### **3.2 SURFACE WATER RESOURCES COMMENTS AND RESPONSES**

Figure 3.2-1: FEMA Flood Insurance Rate Map  
 Rock Hill Development  
 Town of Thompson, Sullivan County, New York  
 Source: Keystone Associates

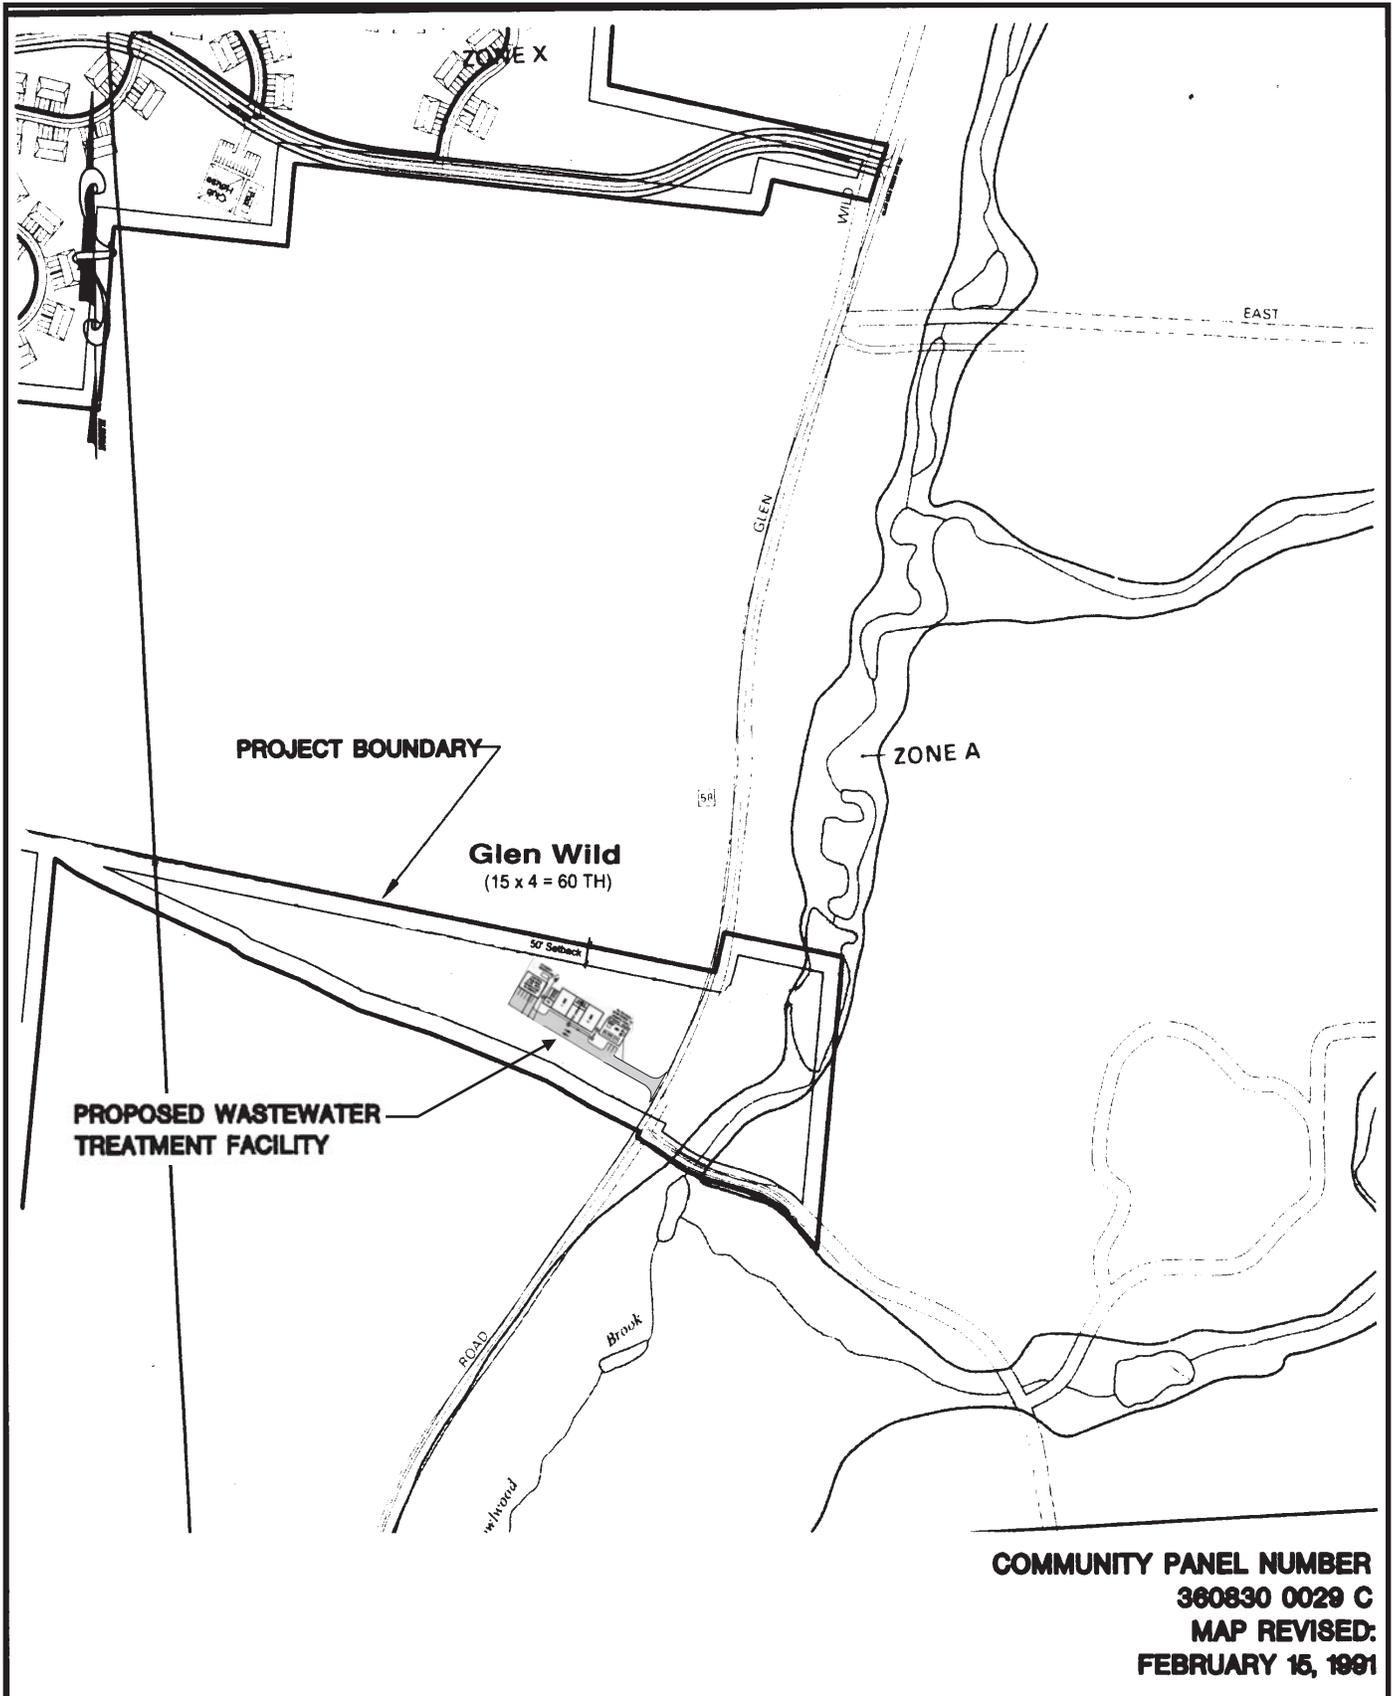
**Comment 3.2-4 (Letter #6: Peter J. Connery, P.E., Environmental Engineer, NYS Department of Environmental Conservation, October 30, 2008):** The discharge of the effluent from the developer's sewage treatment plant will require a DEC permit. The flows associated with a plant of this type are normally small. This flow should not have an impact on your EAP. I would advise the Town's Planning Board that the EAP exists, that the community has a copy, and request that any changes in the EAP that are necessary because of the development should be borne by the developer.

**Comment 3.2-5 (Letter #6: Peter J. Connery, P.E., Environmental Engineer, NYS Department of Environmental Conservation, October 30, 2008):** We have discussed the fact that the Town of Thompson is in the National Flood Insurance Program, the town needed to enact laws that limits/controls development in a flood zone. Fowlwood Brook is situated in a flood zone. This should be explored further. I have enclosed a portion of Flood Insurance Rate Map that is pertinent to the area you described to me for your use.

*Response 3.2-5: Comment noted. Refer to Figure 3.2-1 for a depiction of the proposed development superimposed on the Federal Emergency Management Agency (FEMA) Flood Insurance Rate Map (FIRM) which indicates Fowlwood Brook and the associated 100 year flood plan (Zone A). The Wastewater Treatment Facility, which has been relocated to the west side of Glen Wild Road, is not within the 100 year flood Plain.*

Figure 3.2-2: Wanaksink Lake Dam Inundation Map  
 Rock Hill Development  
 Town of Thompson, Sullivan County, New York  
 Source: Keystone Associates

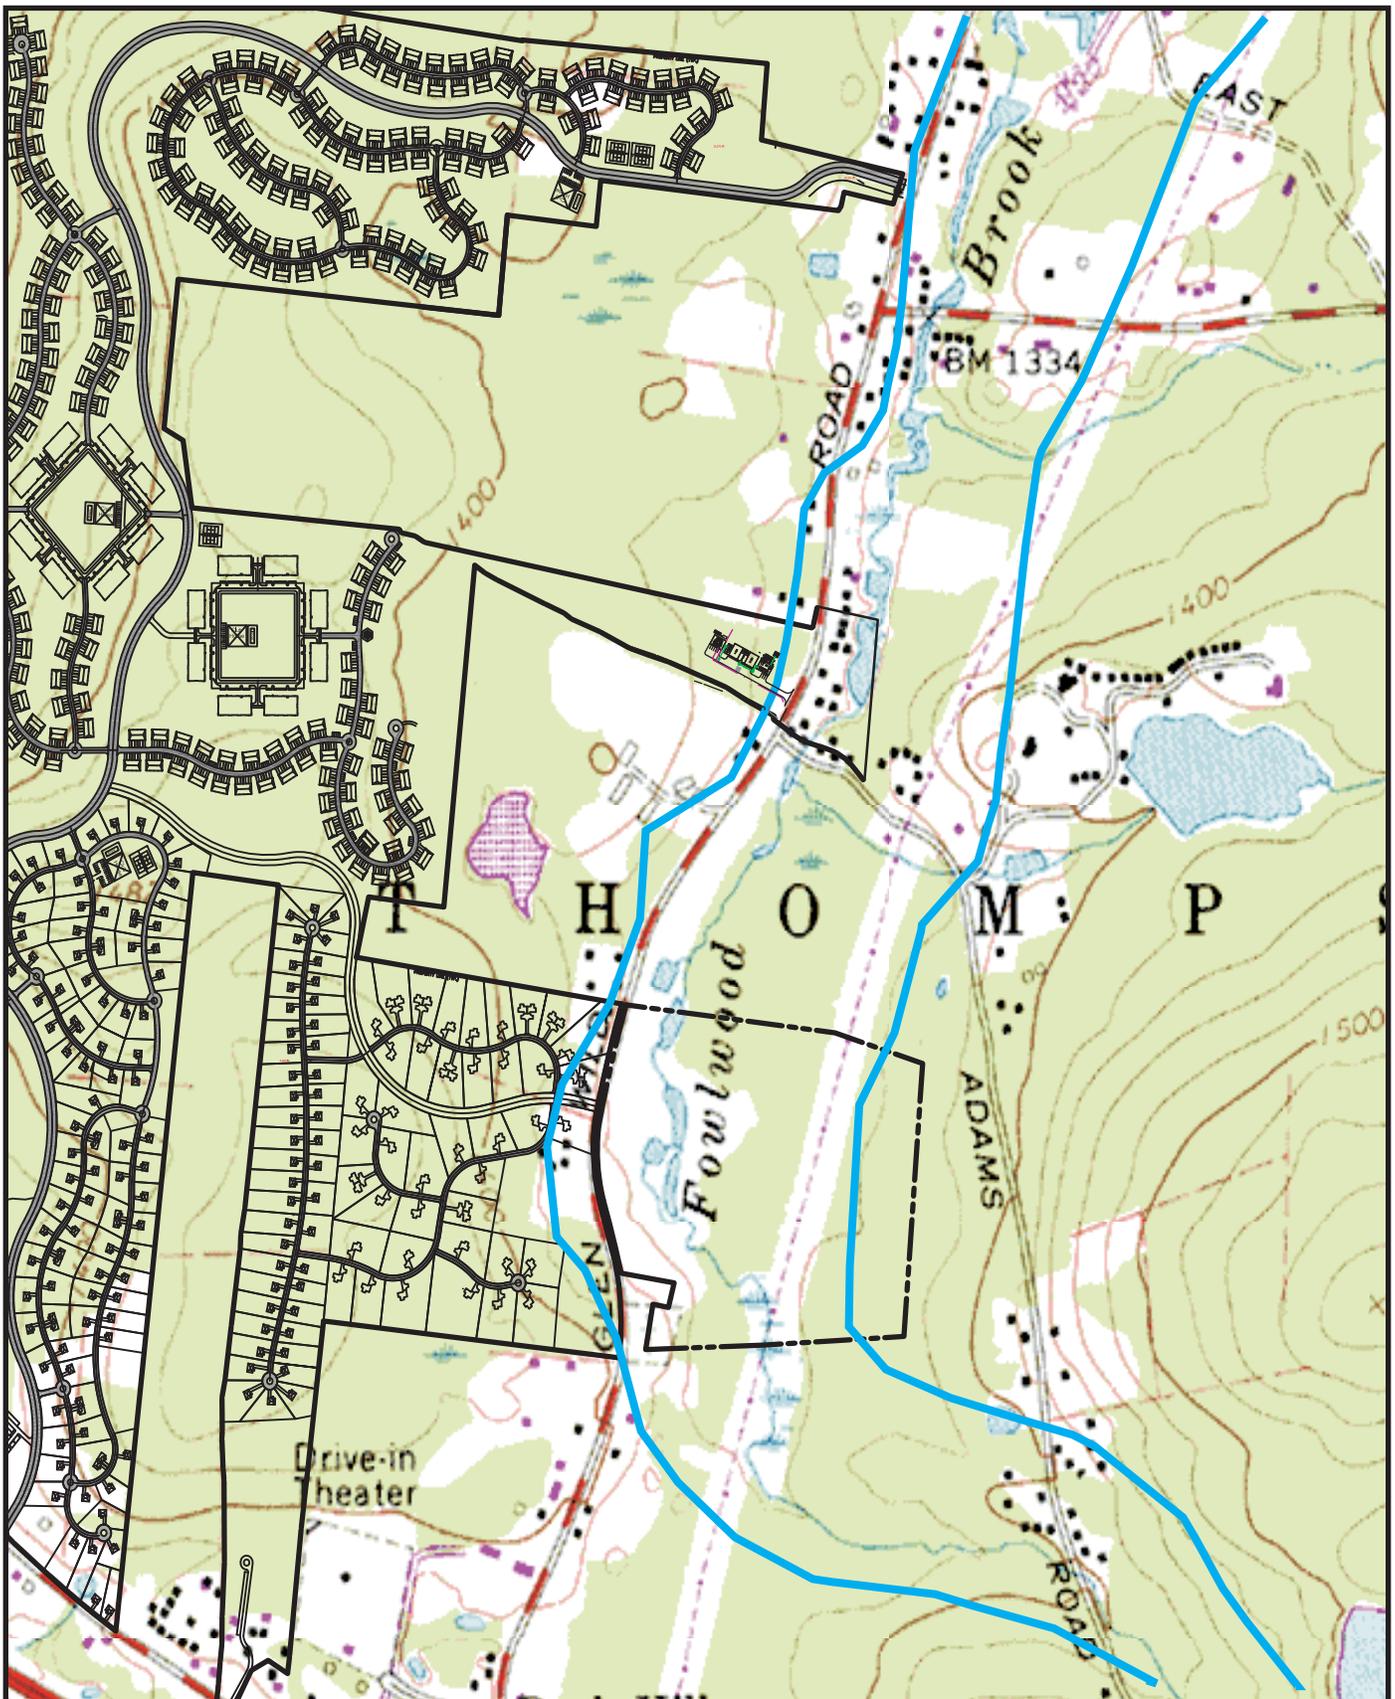
**Comment 3.2-6 (Letter #7: John Konefal, President, Wanaksink Lake Club, undated):** Our second grave concern has to do with the Wanaksink Lake Emergency Action Plan (EAP), drawn by engineers, reviewed by the DEC and filed with the Town Supervisor. That plan clearly shows that breached waters would end up in the rock hill Town Center construction site. According to the development maps, buildings and also the proposed area of the developments sewage treatment plant would be inundated with water. Attached is a copy of the developers site plan with an overlay of our inundation map showing the flow of water. Therefore not only would the spillway from the Wanaksink Lake dam destroy homes and endanger lives but it would also likely wash out the sewage treatment plant causing polluted waters to travel even further downstream through other residents property and eventually into the Neversink River. Also, the Town of Thompson is in a National Flood Insurance Program with flood maps on file in the Town Building Department Office. A review of these maps would show that the area of

Fowlwood Brook in Glen Wild, is in that flood zone. Therefore we are requesting that Wanaksink Lake be indemnified by the developer, for the life of the development, if any emergency water flow causes damage to their structures, any other structures or sickness or death to any person anywhere downstream of the development.

**Response 3.2-6:** *Figure 3.2-2, Wanaksink Lake Dam Inundation Map shows the approximate boundary of the inundation water. As shown, the treatment facility is now located on the west side of Glen Wild Road entirely outside of the inundation zone.*

*It should be noted that there is no requirement to restrict development of any project to areas entirely outside of an inundation zone. If required, the Applicant will work to move the proposed development units outside of the inundation zone.*
